SERVICE BULLETIN**N° 139-661****ALERT****DATE:** February 4, 2021**REV. :** B - May 9, 2022

TITLE**ATA 24 – OVERHEAD PANEL INSPECTION****REVISION LOG**

Revision B of this Service Bulletin has been issued to close the effectivity of the Part II.

Figure 1

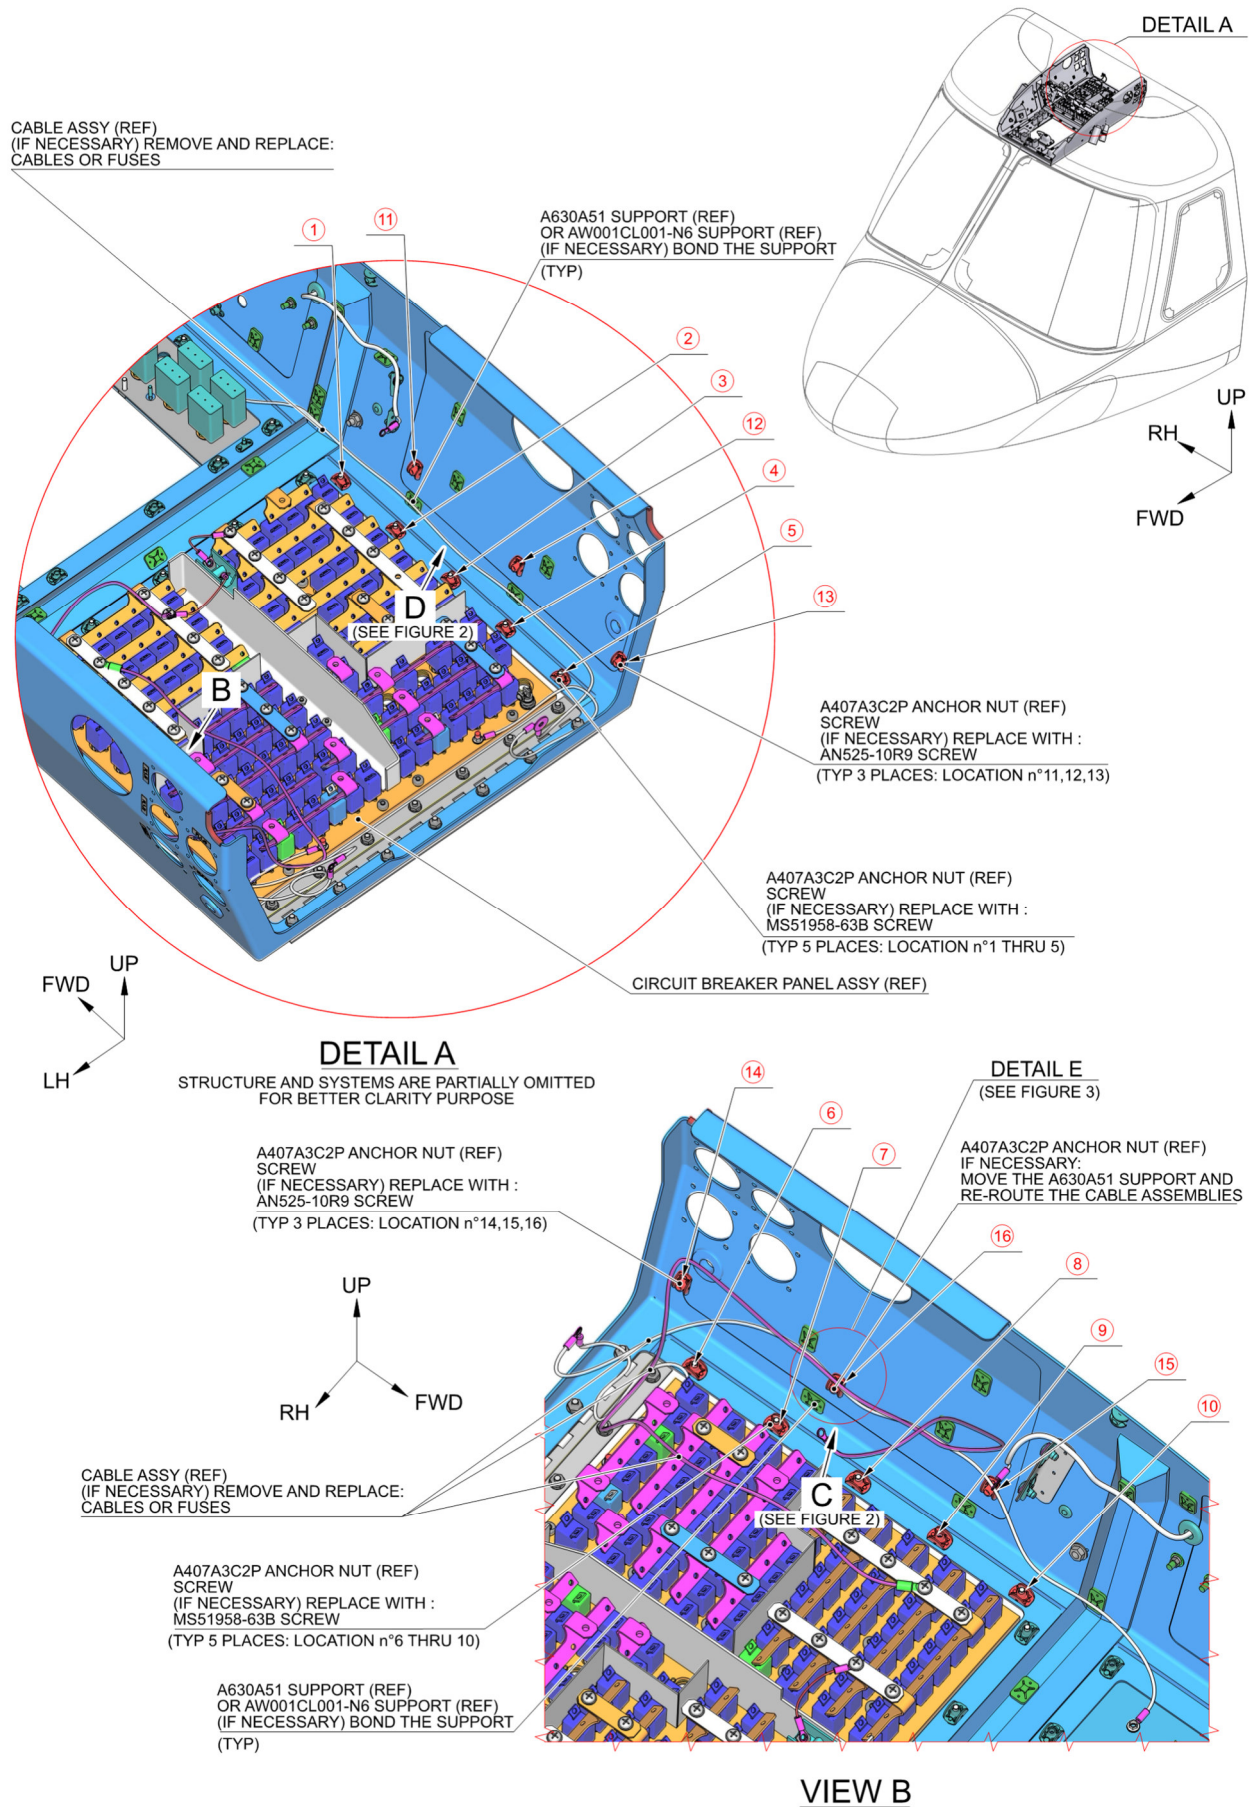
- 2.2 With reference to Figure 1 detail A and View B, remove the screws and the washer and check the screw length at the indicated locations from n°1 thru n°10 according to the following procedure:

- 2.4 With reference to Figure 1 Detail A and View B, check for chafing damage of the cable harness and ensure that clearance exists between the cable harness and the anchor nuts P/N A407A3C2P and/or the screws at the indicated locations from n°1 thru n°16.

- 2.6 With reference to Figure 1 View B and to Figure 3 Detail E, measure at the indicated location n°16, on the LH side, the clearance between the anchor nut P/N A407A3C2P and the cable harnesses including a check of the mutual position.

- 2.7 In accordance with the applicable steps of AMP DM 39-A-20-10-19-00A-920A-A and with reference to Figure 1 View B, move the existing support P/N A630A51 or P/N AW001CL001-N6, as applicable, and re-route the cable harnesses in order to respect the clearance of at least 10.0 mm and guarantee the installation ABOVE the anchor nut.
- 2.8 With reference to Figure 1 Detail A and View B, check that all the supports P/N A630A51 and P/N AW001CL001-N6, as applicable, on the LH and RH side are soundly bonded to the panel with no evidences of detachment or delamination.

- 2.11 With reference to Figure 1 Detail A and View B, to Figure 2 View C and View D, apply n°2 layers of the white tape P/N AW005ME04T05305 (or equivalent P/N listed in consumable list) on n°10 anchor nuts P/N A407A3C2P (n°5 on the LH side and n°5 on the RH side).

Figure 2

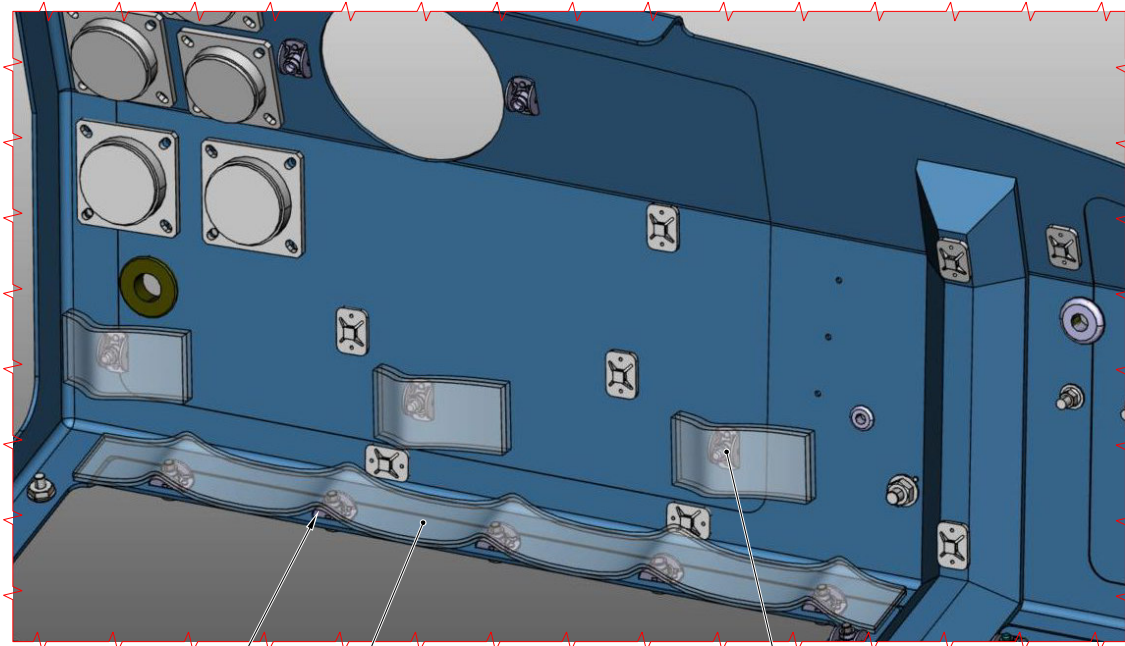
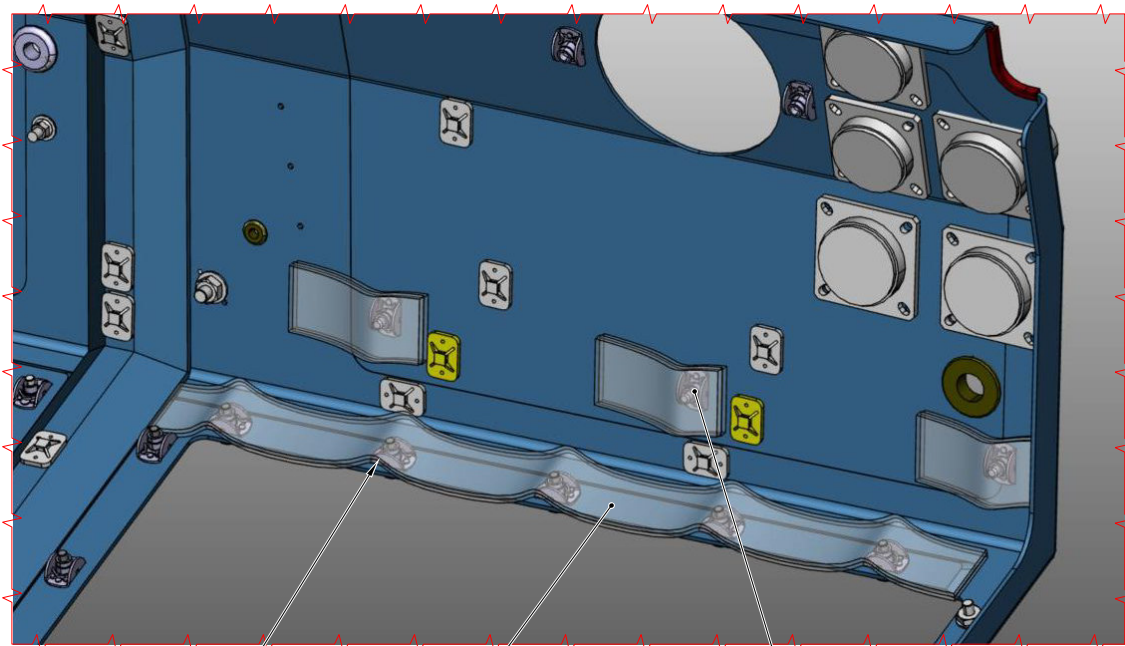
- 2.12 With reference to Figure 1 Detail A and View B, to Figure 2 View C and View D, apply n°2 layers of the white tape P/N AW005ME04T05305 (or equivalent P/N listed in consumable list) on each of the n°6 anchor nuts P/N A407A3C2P (n°3 on the LH side and n°3 on the RH side).

- 2.2 With reference to Figure 1 Detail A and View B, to Figure 2 View C and View D, check for the condition of the n°2 layers of the white tape P/N AW005ME04T05305 (or equivalent P/N listed in consumable list) on n°10 anchor nuts P/N A407A3C2P (n°5 on the LH side and n°5 on the RH side).

- 2.4 With reference Figure 2 View C, remove n°2 layers of the white tape from the anchor nuts and apply in the same position n°2 new layers of the white tape P/N AW005ME04T05305 (or equivalent P/N listed in consumable list).

- 2.5 With reference to Figure 2 View D, repeat step 2.4 for the RH side.

Figure 3

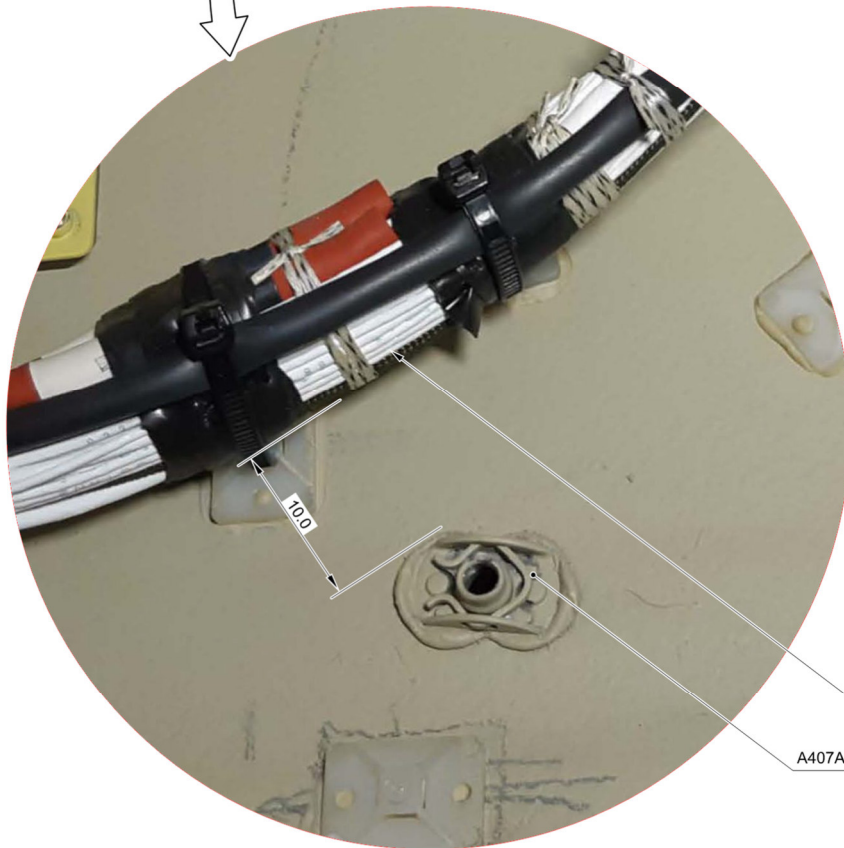
Perform the following step 2.7 if the clearance is NOT at least 10.0 mm and/or if the cable harnesses is installed BELOW the anchor nut.

Figure 5

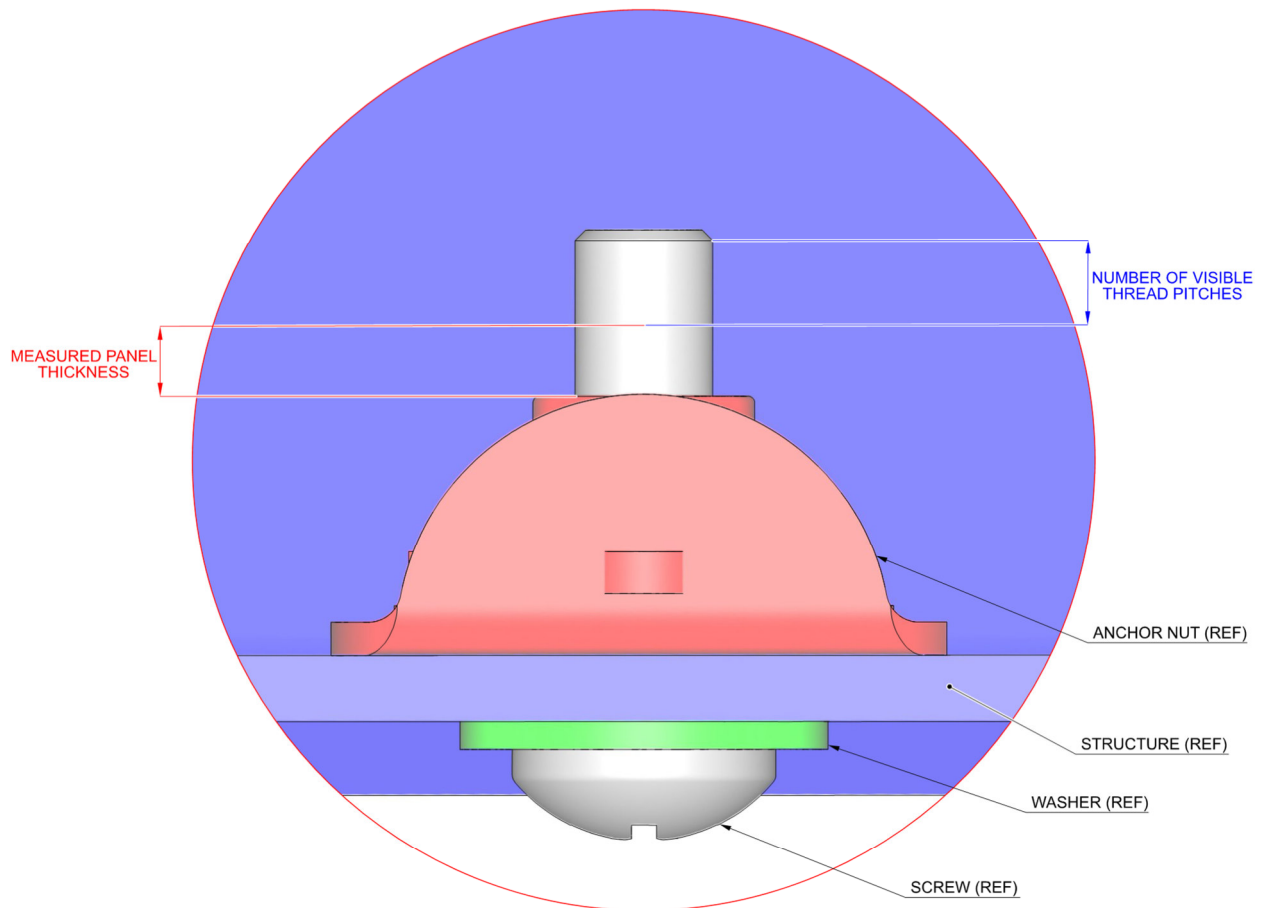
- 2.2.3 Visually check that the number of thread pitches remained visible out of the anchor nut is between 2 and 4 after having subtracted the panel thickness value previously measured (refer to Figure 5).
- 2.2.4 If, when subtracted the panel thickness, less than 2 or more than 4 screw thread pitches remain visible, change the screw according to the following procedure:

Figure 6

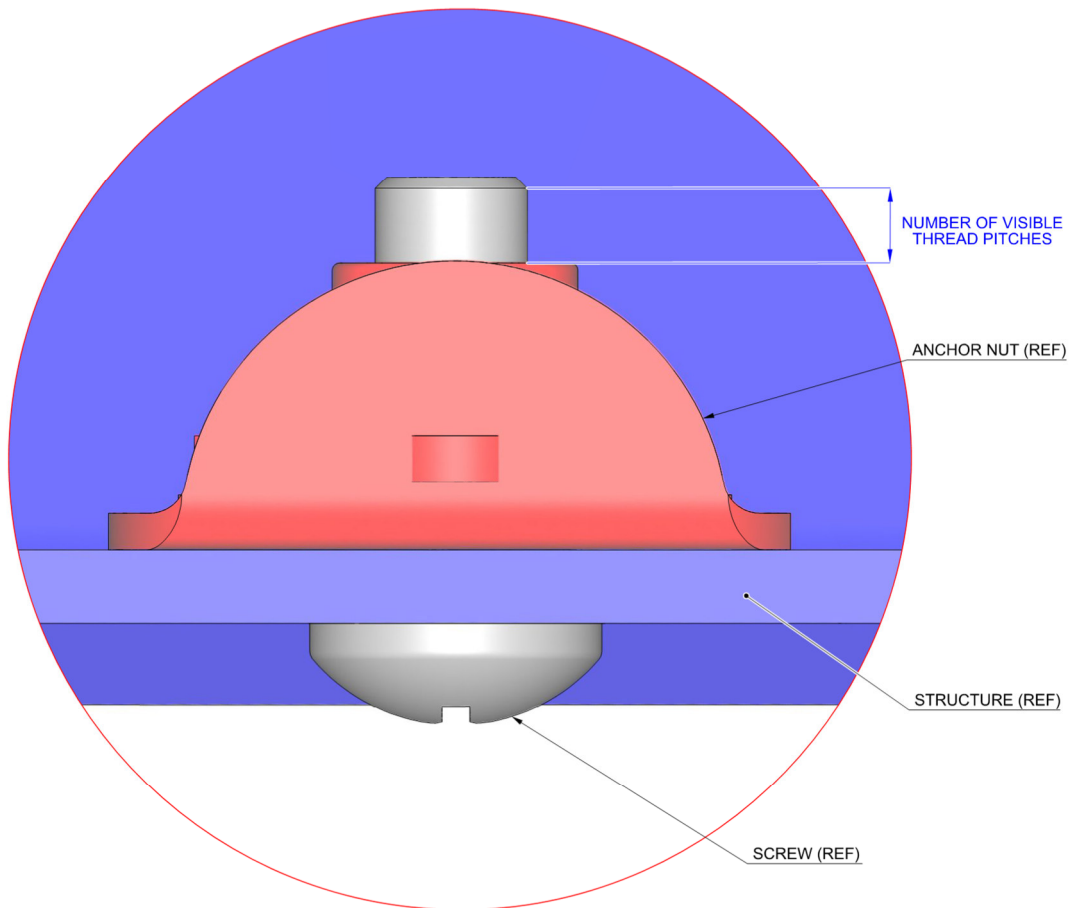
- 2.3 With reference to Figure 1 detail A and View B, check the screws length at the indicated locations from n°11 thru n°16, if applicable, according to the following procedure:
 - 2.3.1 Visually check that the number of thread pitches remained visible out of the anchor nut is between 2 and 4 (refer to Figure 6).
